# Product Change Notification

**Product Change Notification:** PCN-22-156580

PE & RE/L relay series - adhesive

The color of the adhesive before the change

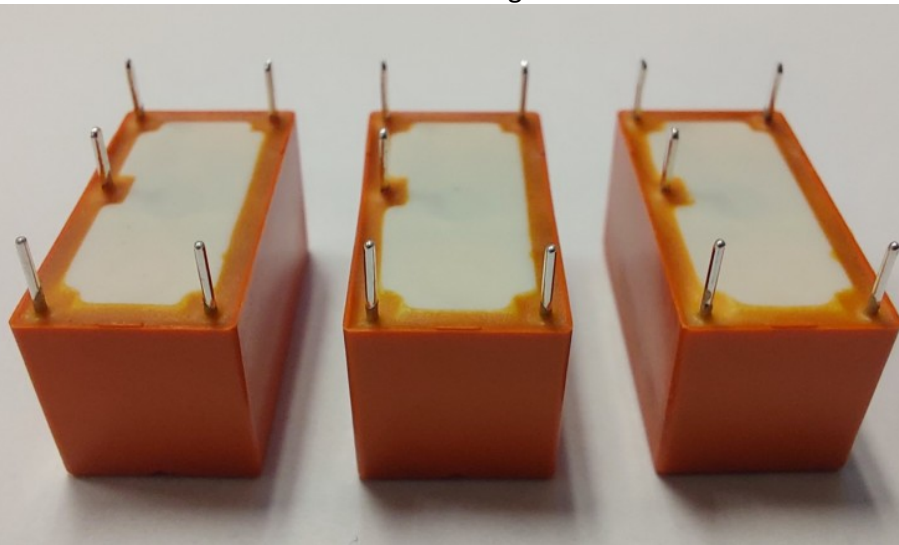
Dear customer, this PCN is a correction of PCN-22-125558 as we do not make use of a white adhesive but have qualified an orange adhesive. The reason for the change keeps the same: To keep aligned with the regulations of RoHS not just for the finished relay but also throughout the complete process of production we change the sealing adhesive. The following qualification tests did not show any difference to the current adhesive: contact compatibility test, thermal endurance, mechanical endurance, relay tightness test.
